ADDENDUM #1

ADDENDUM 1
BIDDER QUESTIONS AND RESPONSES
POSTED: 12/18/2024
CITY BID NUMBER: SM2024-0035

Project: SIMMONS BRANCH DRAINAGE IMPROVEMENT PROJECT PHASE 2 - Scour Repair at 3609 Swift Dr

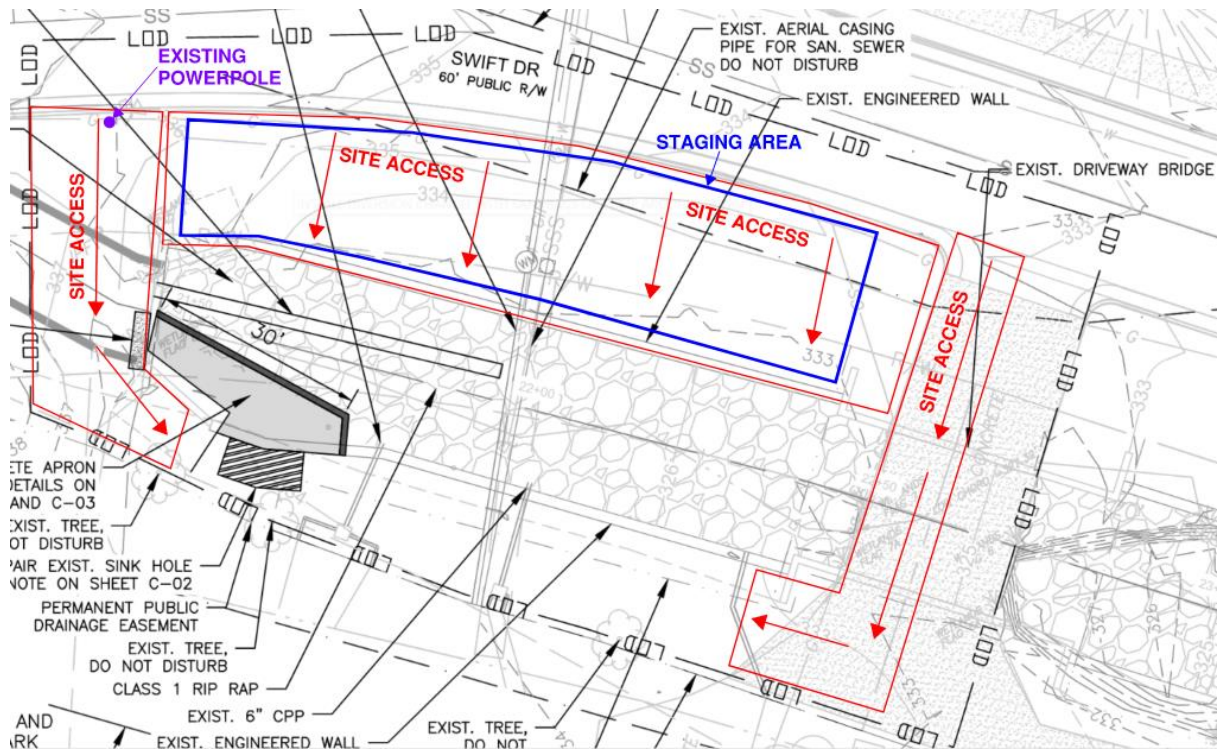
7. We fail to identify the access plan and staging for this project. And possible conflicts with existing utilities.

- a. Will the post north of the project location be relocated. This seems to be the only place to back up a dump truck to dump materials.
Response: This post is approximately 22 ft from the culvert headwall. It will not be relocated. Material dumping is permitted only in the Staging Area adjacent to the curb between the culvert headwall and the driveway bridge; please refer to the graphic shown above.

- b. Is this post for telecommunications only? This post and lines seem not to be in the drawings.
Response: This post is for the powerline; it is shown in the graphic above.

Response: Access to the site is from the curb in front of 3609 Swift Drive, through the driveway bridge to this home, and through the area within LOD behind the culvert headwall; please refer to the graphic below. Only pedestrian access and small equipment like a wheelbarrow are permitted on the driveway bridge. Staging area for temporary material storage is the grass area adjacent to the curb between the culvert headwall and the driveway bridge.
